REQUEST FOR PROPOSALS
FOR THE PURCHASE AND DEVELOPMENT OF THE FIRST PHASE OF THE CREEDMOOR MIXED-USE PROJECT

Addendum #3

QUESTION AND ANSWER

Phase A RFP Q&A Figure 1 - Lot B2 Boundary

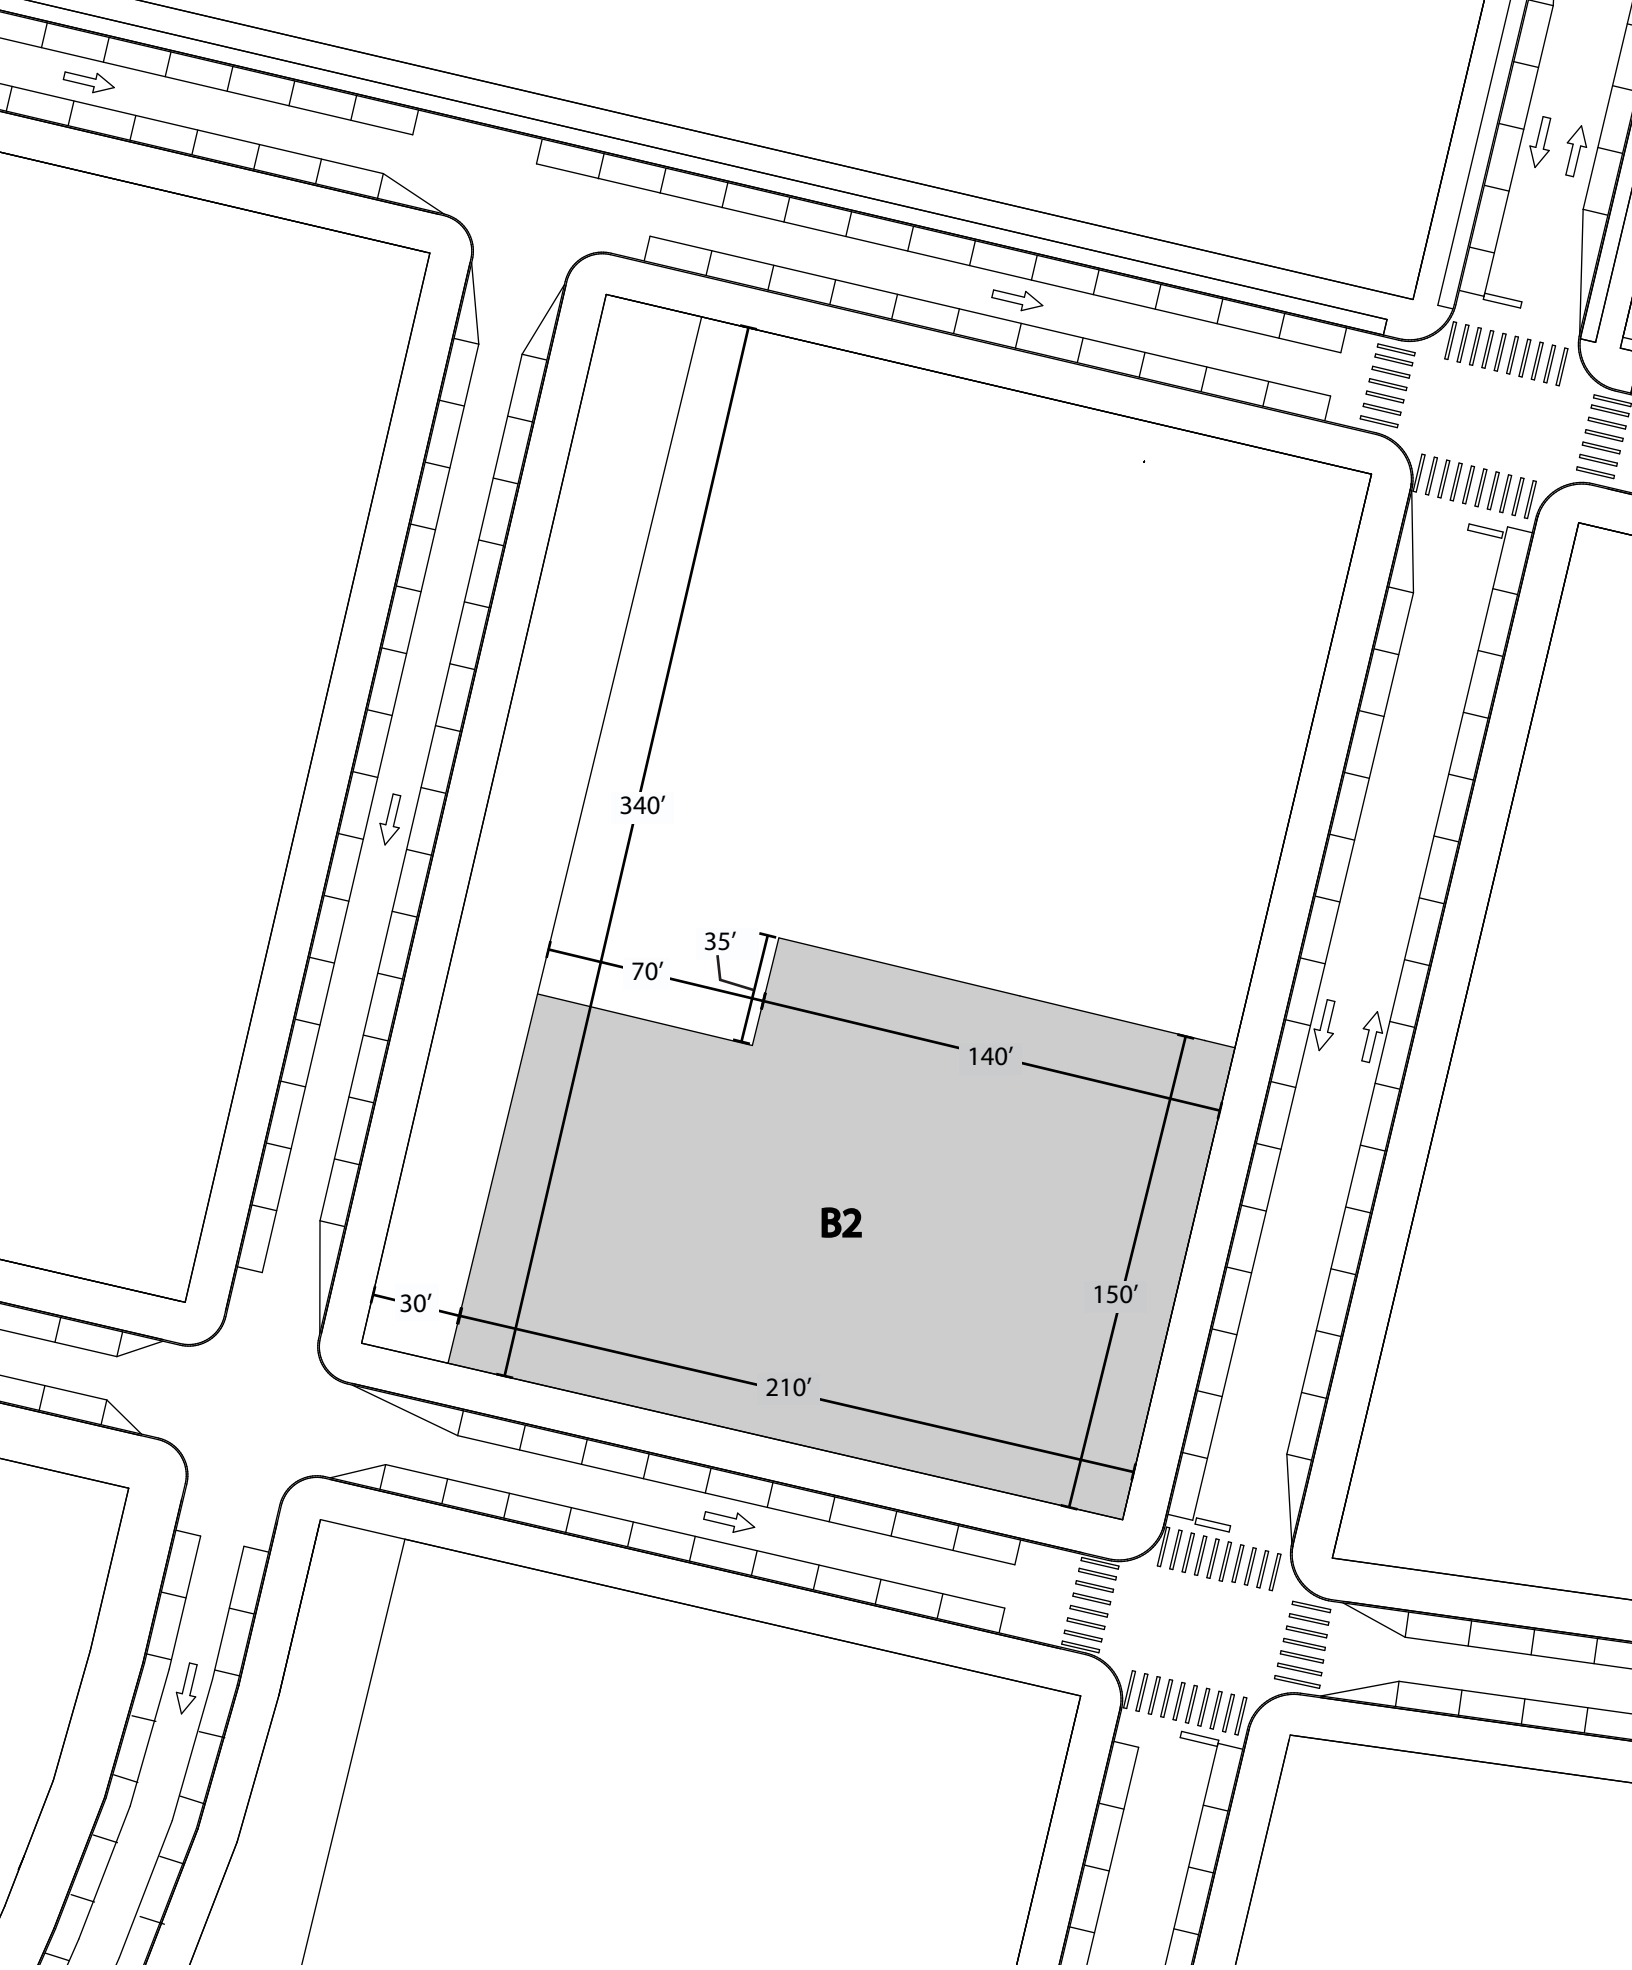
No.	Question	Answer
40	**Appendix D: Design Guidelines, Fig. B-01:** Please clarify the exact boundary between Lots B2 and B3. The drawings indicate a combined width of 340 feet and a depth of 210 feet; confirmation of the individual lot dimensions and demising line is requested.	See attached Q+A Appendix 1 (Figure 1) for Lot B2 dimensions.
41	**Appendix D: Design Guidelines, Fig. A-02:** Please confirm the maximum permitted building envelope height for Lot A2.	80 feet.
42	**General:** Are there any planned or long-term transportation improvements, corridor studies, or capital projects for Hillside Avenue that proposers should review or coordinate with as part of the proposed mixed-use development project?	ESD is not aware at this time.
43	**Appendix D: Design Guidelines, Table 2, Page 19:** Can support spaces associated with SMI Housing or Veterans Housing be counted as residential gross floor area, or should they be classified as Community Facility space for purposes of the development program?	For purposes of submission, the accessory residential use should be counted as residential gross floor area.
